Environmental Review Team Report

Edgemere Condominiums

East Hampton, Connecticut

ENVIRONMENTAL REVIEW TEAM REPORT
ON
EDGEMERE CONDOMINIUM DEVELOPMENT
EAST HAMPTON, CONNECTICUT

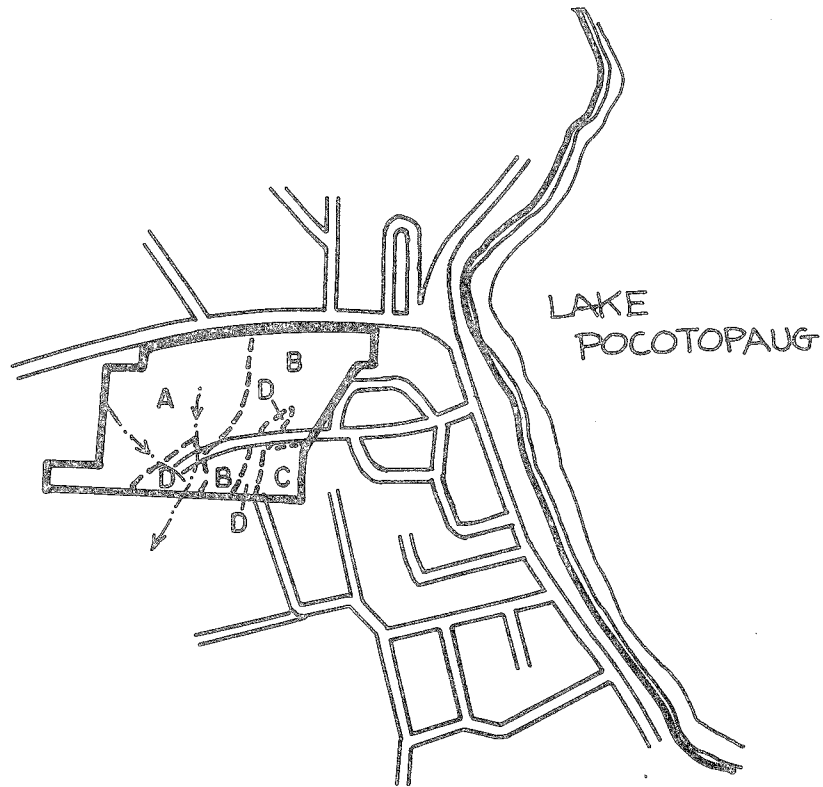
Storm drainage management is very important in a development with a density such as in this proposed section of Edgemere. The Planning and Zoning Commission or its review engineer should pay careful attention to the storm drainage design, not only to determine its adequacy, but also to determine the impact on the environment and on traffic operations.

The design engineer should submit a plan showing the drainage areas for each basin and "leak-off" in addition to submitting the drainage calculations to

aid in the review process. The drainage calculations should be scrutinized; the coefficient of runoff does not seem consistent with the land use. Therefore, the specified pipe sizes may not be adequate, especially where tied into the storm drainage system in the existing section of Edgemere. The catch basin locations should be analyzed to assure they are adequately spaced to accept the proposed amount of runoff without excessive ponding, and that the locations are consistent with the proposed grading. For instance, catch basins should generally be located on both sides of crowned pavements.

Sediment and erosion control and surface drainage features should also be reviewed. The discharge velocity at the lake outlet is rather high. Some plan is needed to reduce the velocity in addition to the proposed rip-rap. The effect of grading on surface drainage both on and off the pavement, and the method of discharging roof drains should also be examined.

It is recommended that a detailed sediment and erosion control plan be developed, consisting of:

1. Location of areas to be stripped of vegetation, and other exposed or unprotected areas.
2. A schedule of operations to include starting and completion dates for major development phases, such as land clearing and grading, street, sidewalk, and storm sewage installation, etc.
3. Seeding, sodding, or revegetation plans and specifications for all unprotected or unvegetated areas.
4. Location and design of structural sediment control measures, such as diversions, waterways, grade stabilization structures, debris basins, etc.
5. Timing of planned sediment control measures.
6. General information relating to the implementation and maintenance of the sediment control measures.

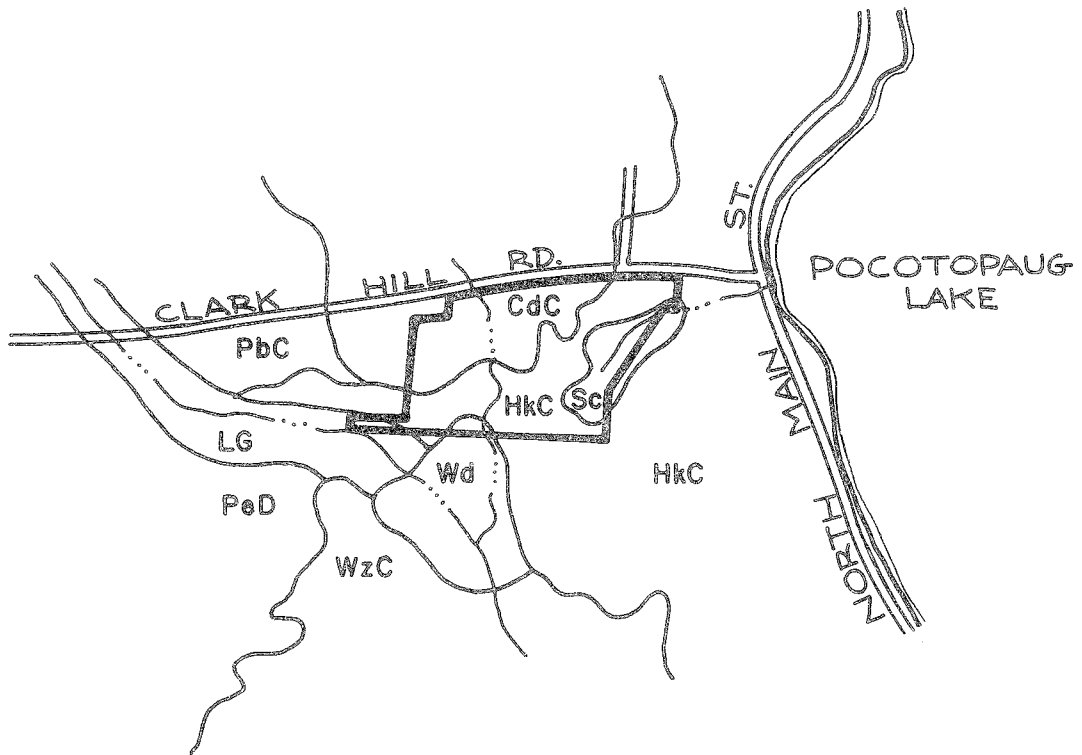
Much of the proposed grading in this development is not desirable and does not meet the design standards for the type of road as specified in the Town Regulations. Much of the grading is too steep, and, in some cases, it is too flat. The changes in grade are not smooth transitions. The intersections are often too steep and are located at through sections with grades in excess of six percent.

The main interior road should be crowned at the center with a cross slope of 1/8" to 3/8" per foot. The parking lot aisles and access roads should also be cross sloped at the same rate, but the crown should be applied either at the center or at one edge. Care should be taken to assure that the parking lot aisles which also act as access roads are not cross sloped at a greater rate than specified above. The cross slopes should accurately be reflected in the proposed grading plan.

All roads should be curbed on both sides as required in the Regulations. A graded, grass shoulder at least four feet wide should be provided for a snow shelf. The shoulder should be graded at one inch per foot towards the road. The shoulder grading should be shown on the proposed grading plan.

All sidewalks should be located outside the shoulder rather than next to the road to allow for snow storage. The sidewalks should be cross sloped at 1/4" per foot towards the road. Handicap ramps should be provided wherever the sidewalk meets the road. The proposed plans should show how the sidewalks will be connected to the condominium unit's doors and the parking areas, where the handicap ramps will be located, and the proposed grading should be accurately shown on the grading plan.
